VEAY LLO Existing Cable Piers Locations

Questions and comments:

END STATION "B" FLOOR PLAN

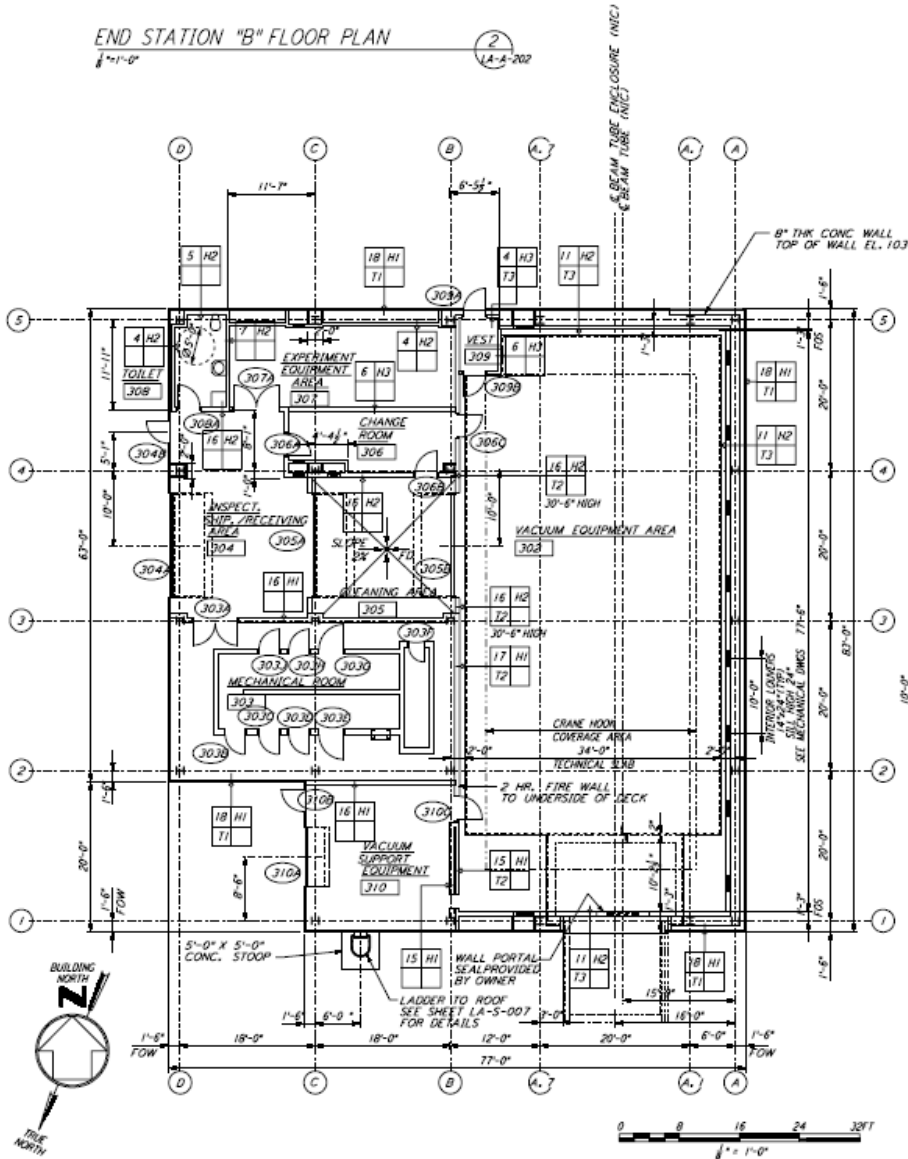
- 1) Where does 11U Short Rack (D1001423-v11) go? (Ignore)
- 2) Where does L1-AOS-YR1 (if it needs to exist) go? (Does not exist)
- 3) What does pentagon-2 mean regarding tray removal? Is there tray across the beam tube from L1-SUS-YR1? (Ignore)
- 4) Is the called-out 10' height important for some reason? LLO height is 8'. (OK)
- 5) What are the double doors in the note all about? (Ignore)
- 6) A door is missing from the garb room to the VEA. (Ignore)
- 7) The doors are missing from the mechanical room. (Ignore)
- 8) L1-VAC-YR1 is missing. (Shown)
- 9) All cabling that currently uses under-beam tray and the waterfall is missing. (Kurt)
- 10) The Photon Calibrator is missing. (Mounted to tube - part of OPLEV)
- 11) VE Pumps are not shown. (Shown)
- 12) Size of ISCB5R is not specified. (72 x 48)

Things that can be done: (Note: Green trace is new tray.)

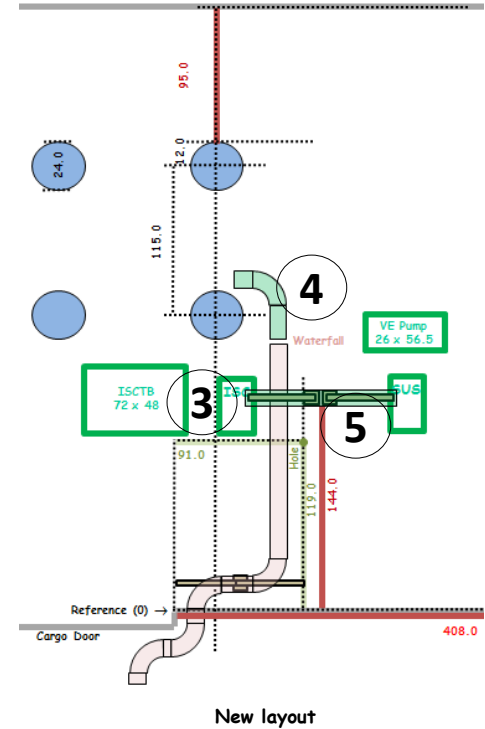
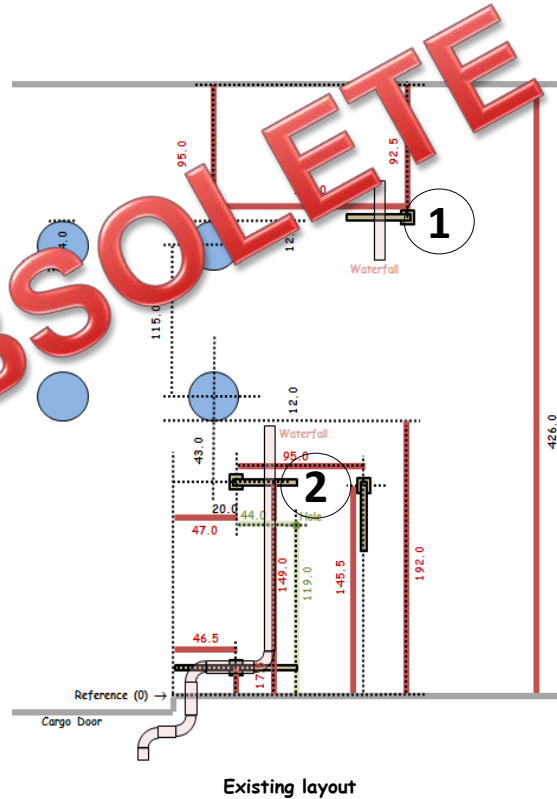
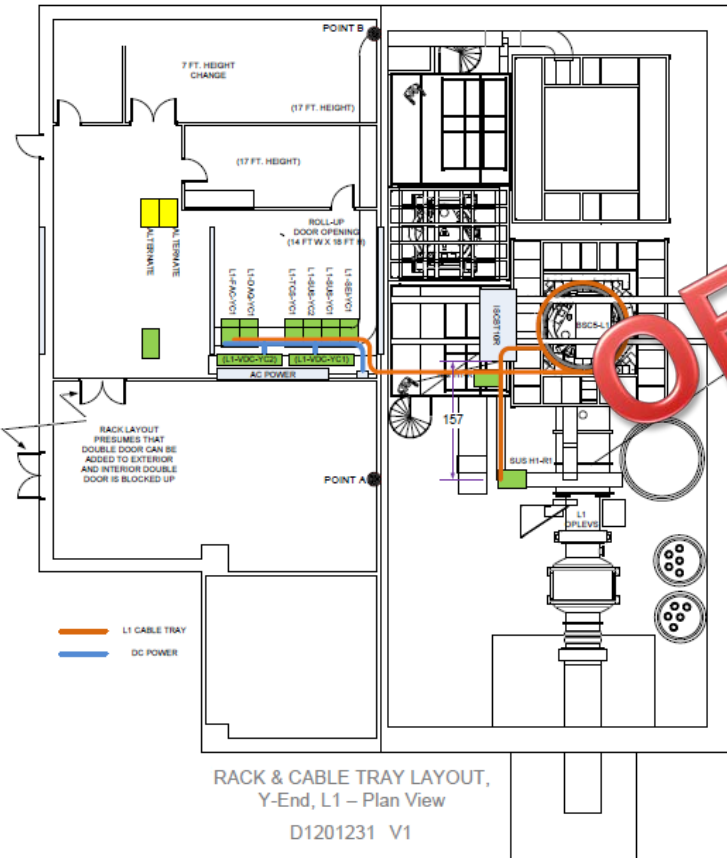
- 1) Remove old cable tray and pier that interferes with dome parking.
- 2) Relocate existing piers to support cable tray to L1-SUS-YR1.
- 3) Locate L1-ISC-YR1 farther away from existing pier for clearance.
- 4) Suggest joining basket around BSC to existing cable tray at waterfall.
- 5) Add cable tray to reach L1-SUS-YR1.

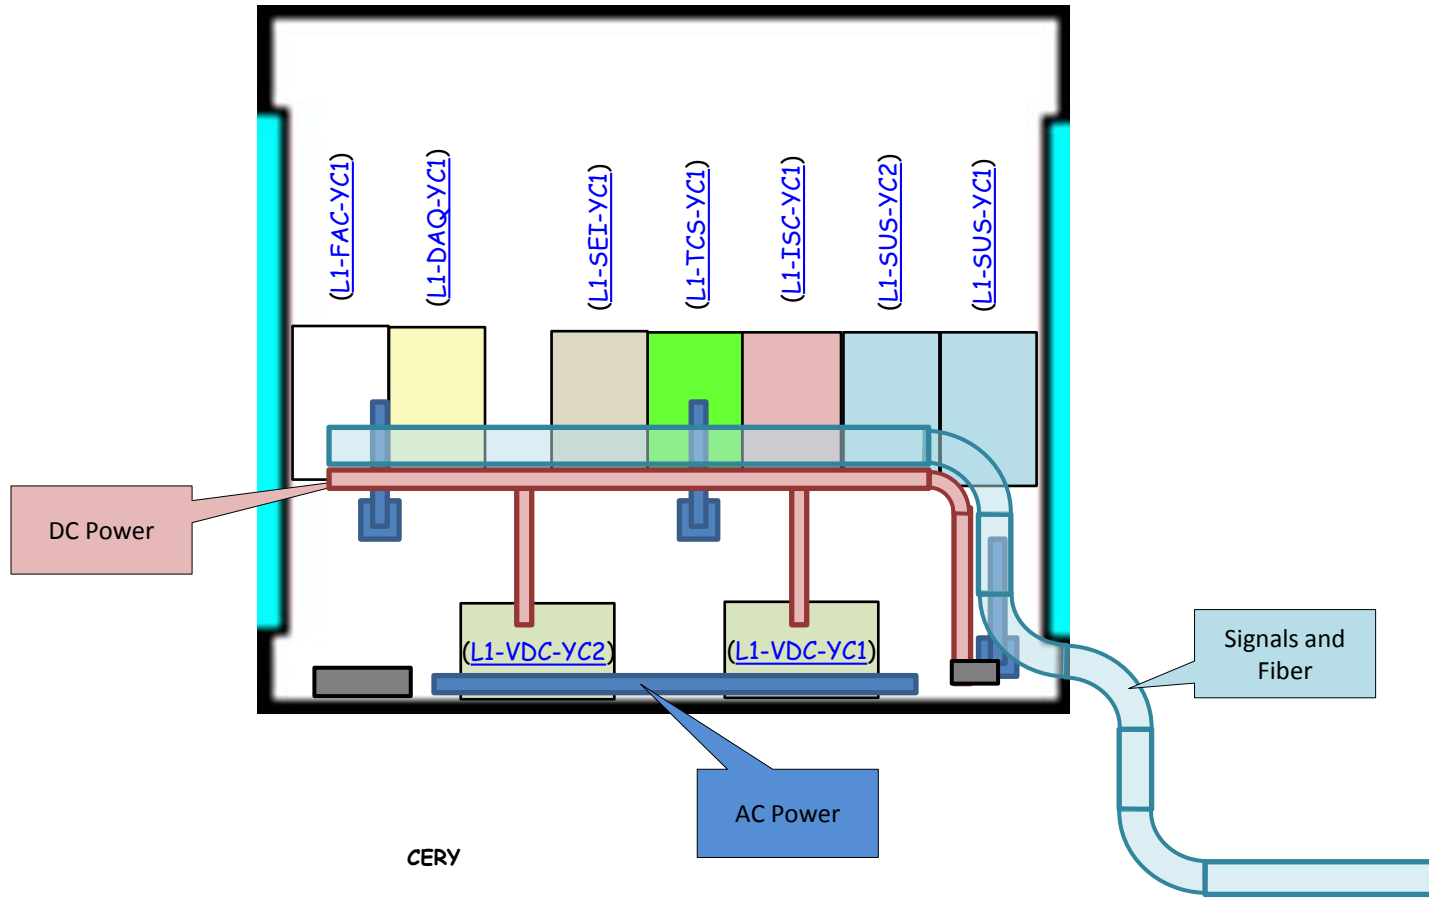
It is 65' from the L1-FAC-YC1 Rack to the knee of the waterfall in the VEAY.
The height of the cable trays is 8'.
